AMERICA'S CUP CLASS

PUBLIC INTERPRETATION No 38

May 8, 2007

FIGURE 1

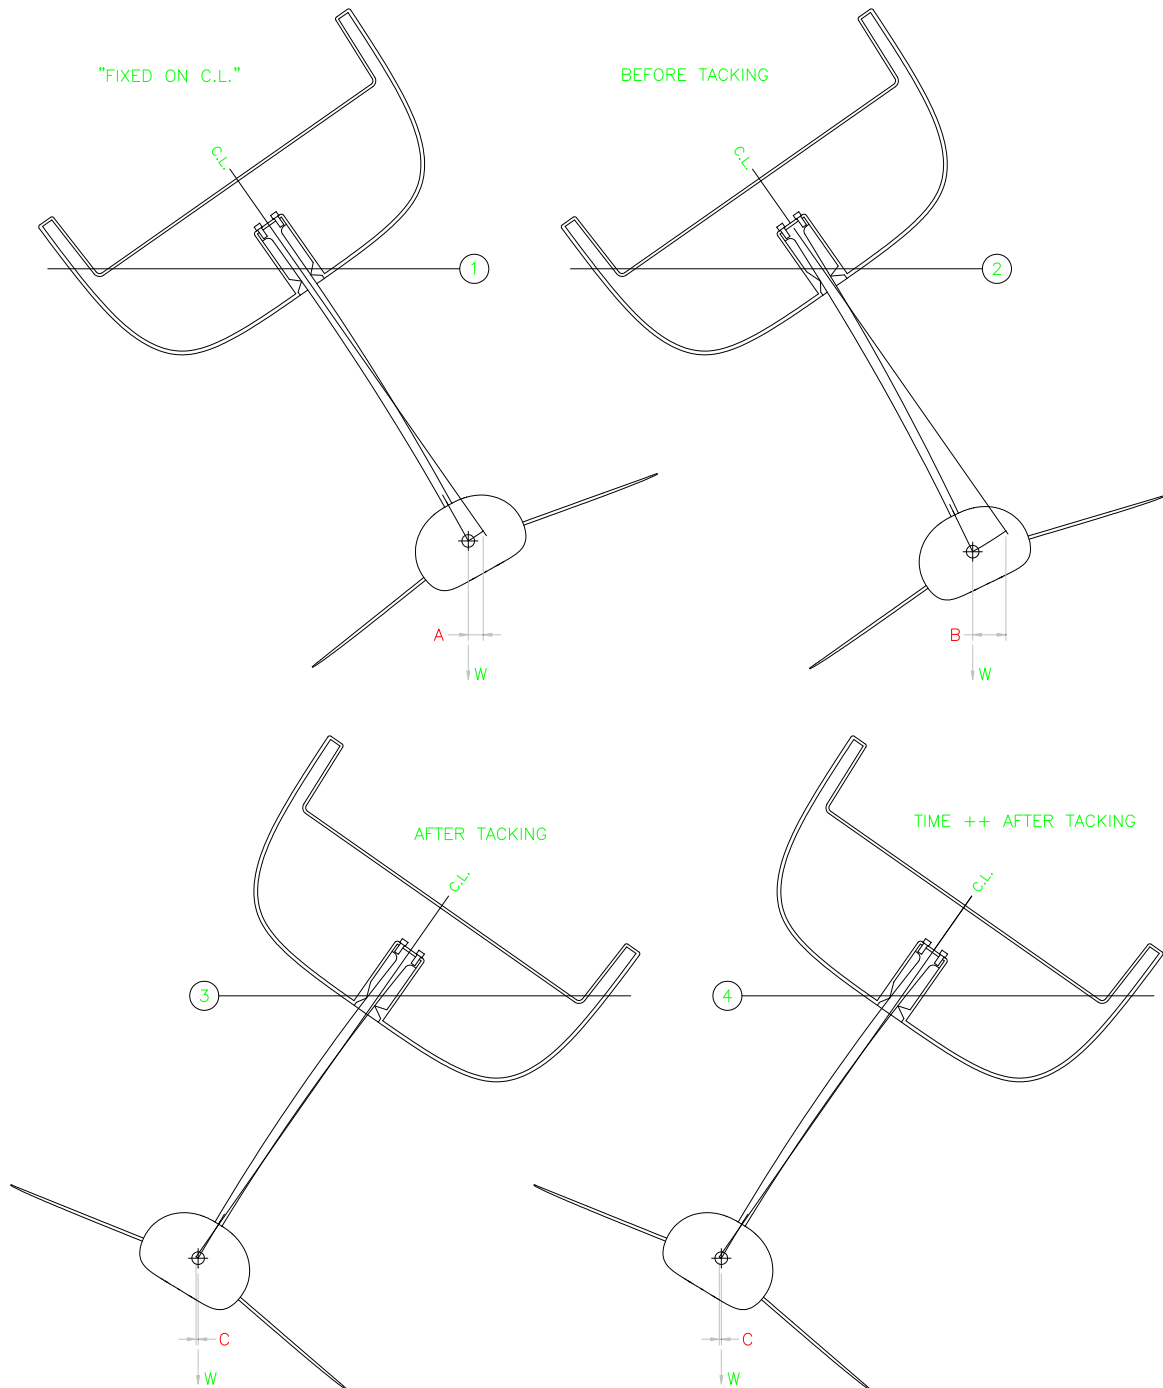
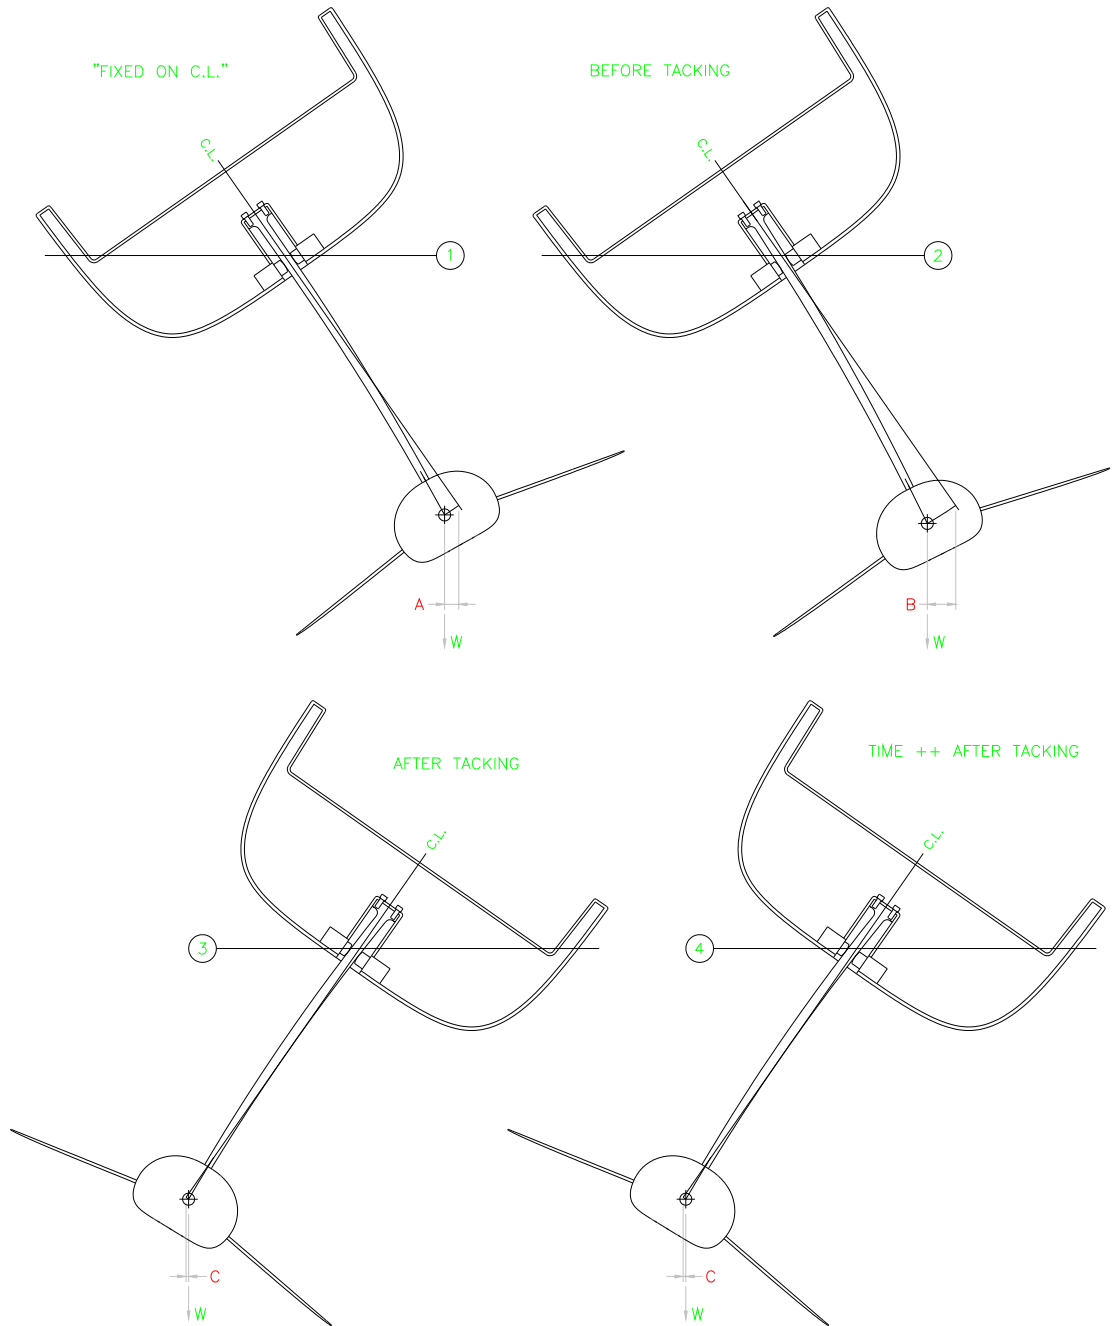
3. *With reference to answer 9 of PI 22, would the requirements for a fixed appendage of Rule 17 also be contravened by the constraint of a fixed appendage in a deflected position arising from the hydrodynamic and gravitational forces as described in answer 4 of the same PI 22? (i.e., Is it permissible to constrain a fixed appendage, by a mechanism which would maintain the deflection either to one side or the other, while deflected to leeward before tacking resulting in some deflection to windward, or less deflection to leeward, on the new tack?) (See as examples Figures 1 & 2).*

2. Yes, an appendage that is supported by structure that alters the deflection of the appendage due to gradual deformation either due to creep, a passive locking system or a damping system would be considered to be a moveable appendage. If the axis of rotation of the appendage is not at an angle to the MWL plane exceeding 45 degrees then it will not comply with Rule 17.10 (b).
3. Possibly. The definition of "fixed" as used in Rule 17 would be contravened if a fixed appendage was constrained by a mechanism which would maintain the deflection to leeward before tacking resulting in some deflection to windward, or less deflection to leeward, on the new tack.
4. Yes. See answer 3 above.
5. Yes. See answer 3 above.

FIGURE 3

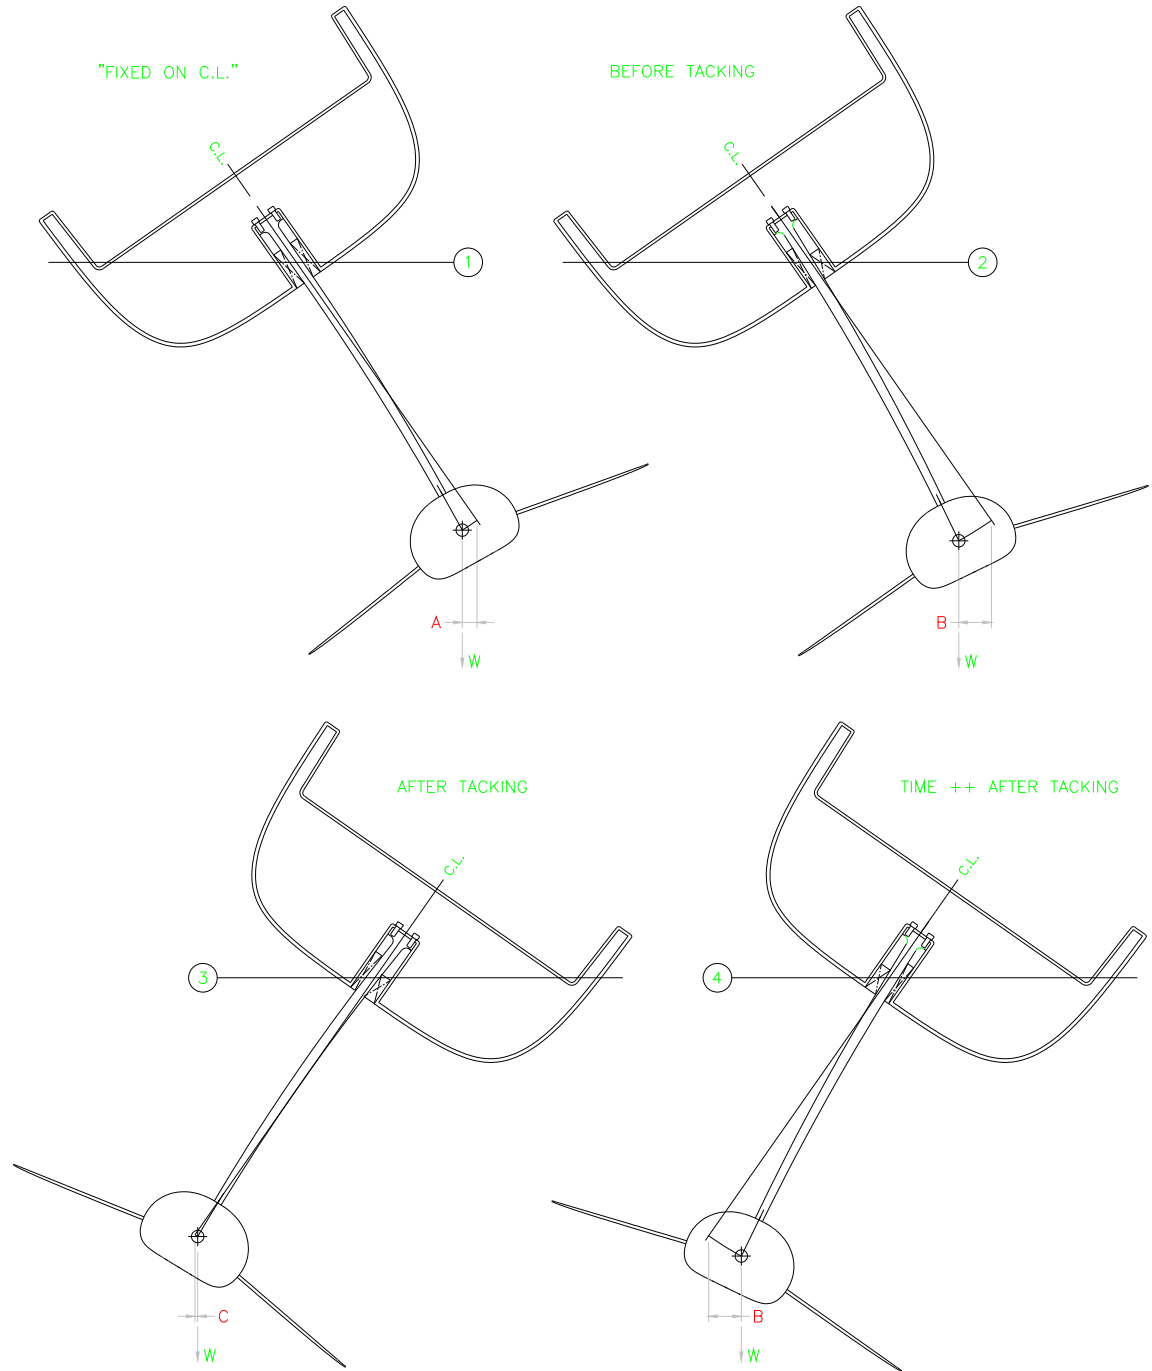
4. *Would the answer to the previous questions be similar if the fixed appendage, or its supporting structure, was not fully constrained but instead restrained thus producing a similar but time dependent behavior when changing tacks (ie, the fixed appendage would gradually return to have similar deflection to leeward on both tacks over some finite period of time)? (See as an example Figure 3).*

FIGURE 4

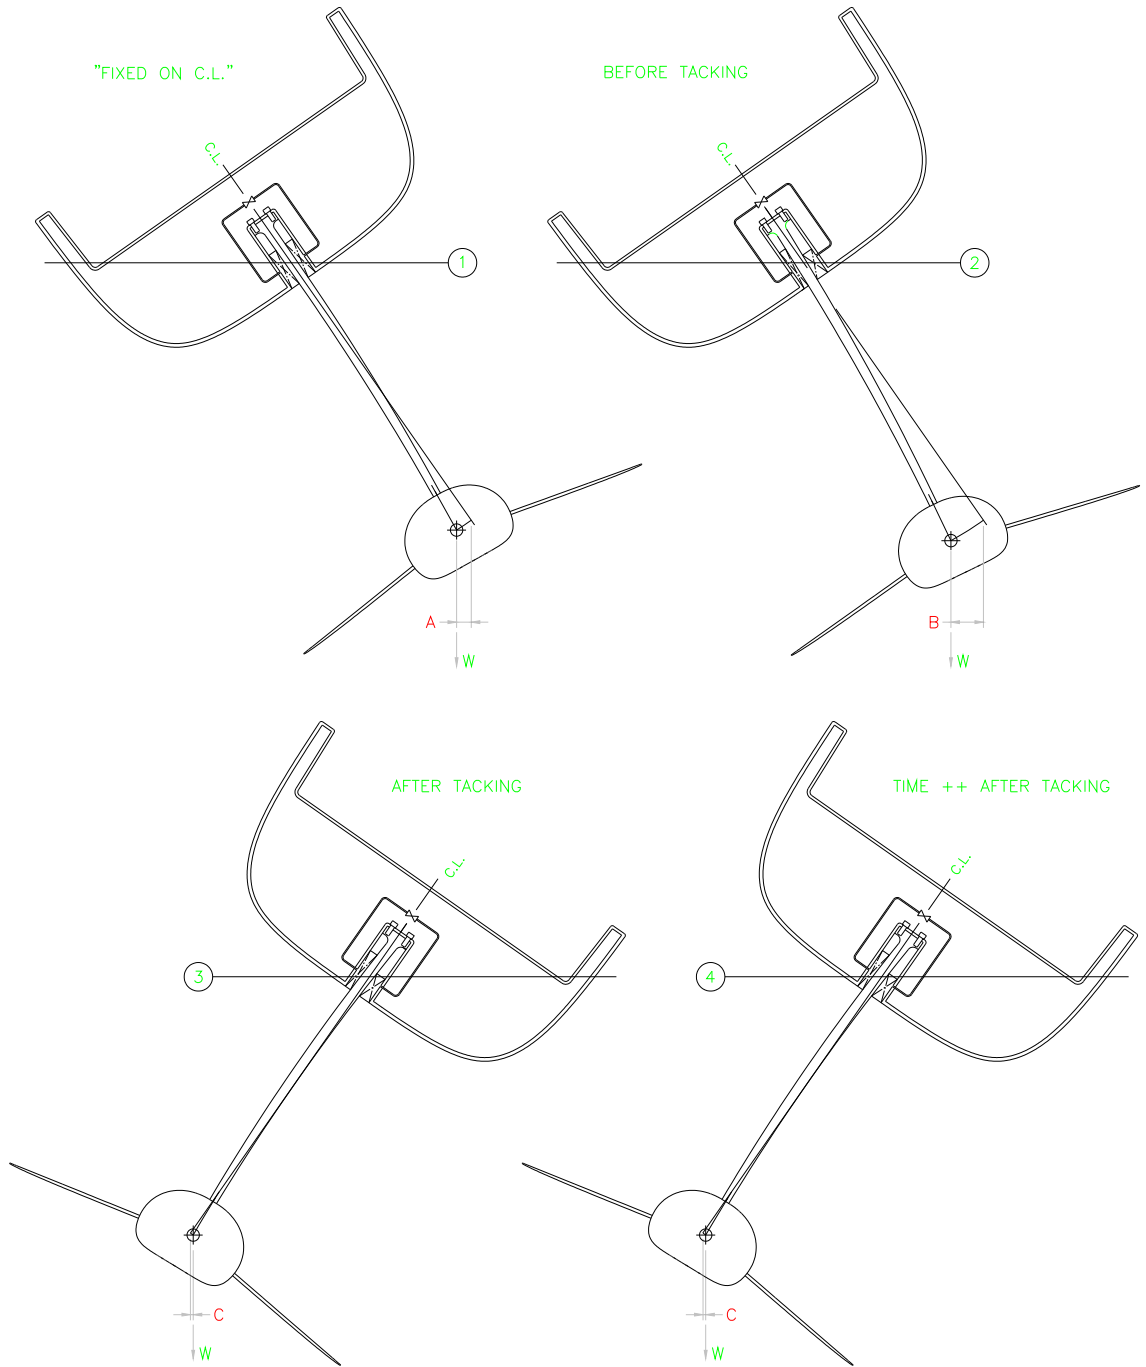
5. *Would the control or adjustment of the constraint or restraint of a fixed appendage while racing contravene rule 17? (See as an example Figure 4).*
